MECHANICAL RENOVATIONS
BOYET JUNIOR HIGH SCHOOL
54295 Rebel Dr.
Slidell, LA 70461

SHEET TITLE:
STRUCTURAL PLAN

DRAWING NUMBER:
S101

1 STRUCTURAL PLAN
SCALE: 1/8" = 1'-0"

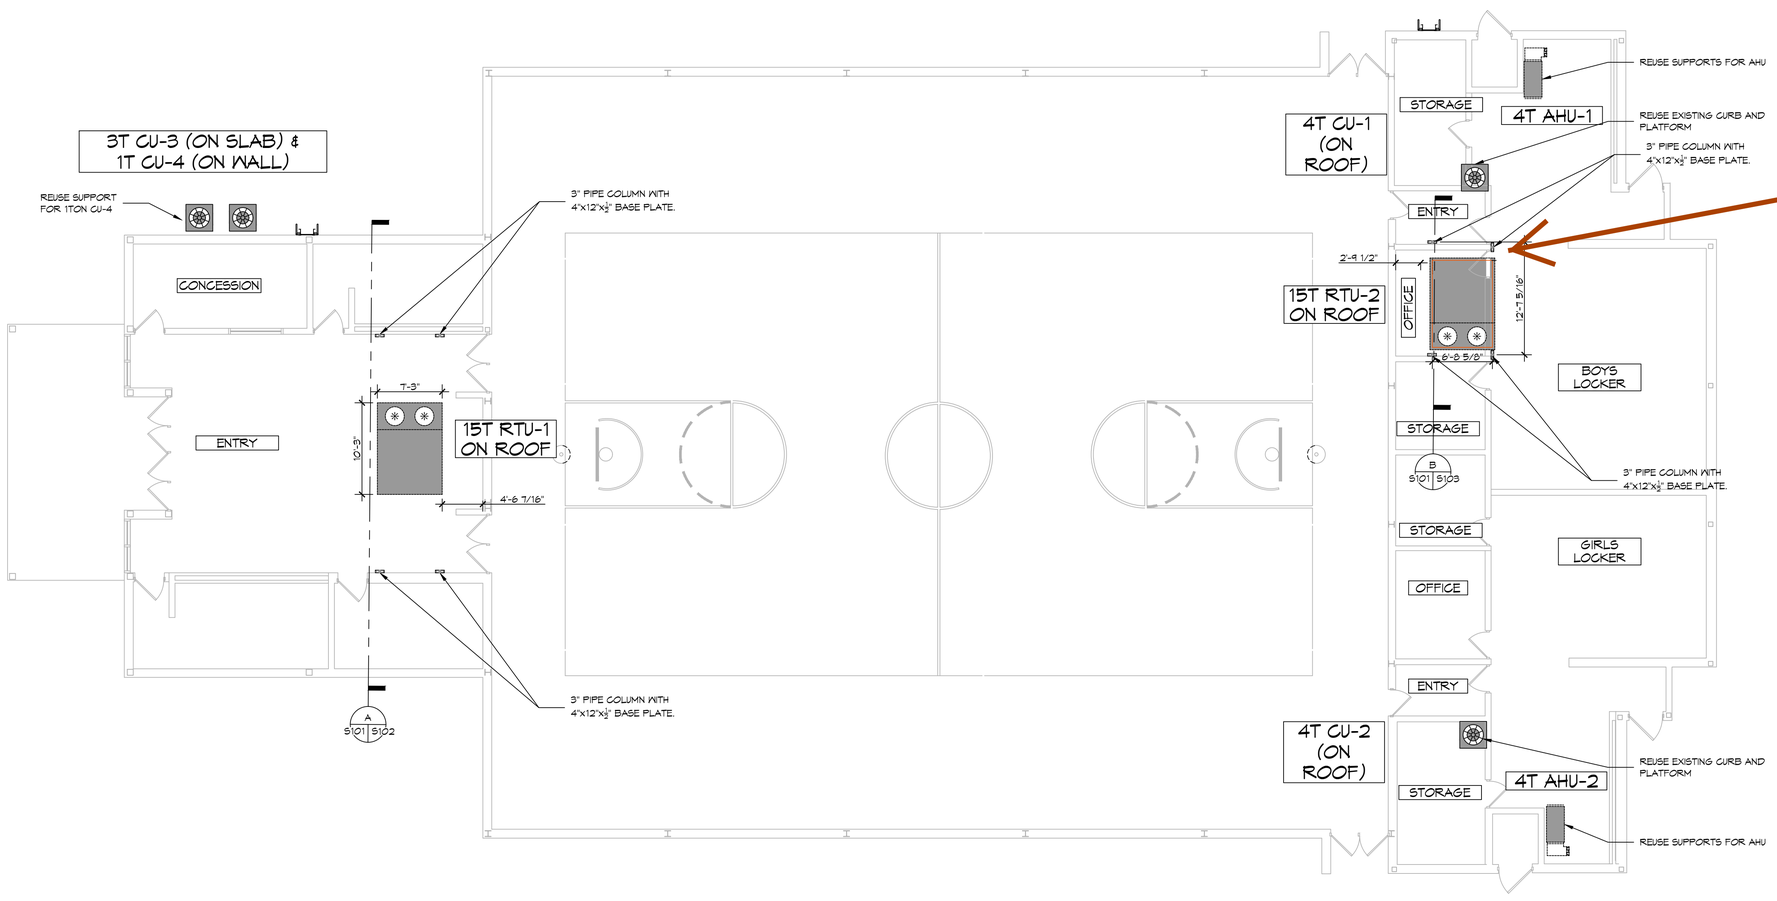
Had to change location.
The door would hit the column
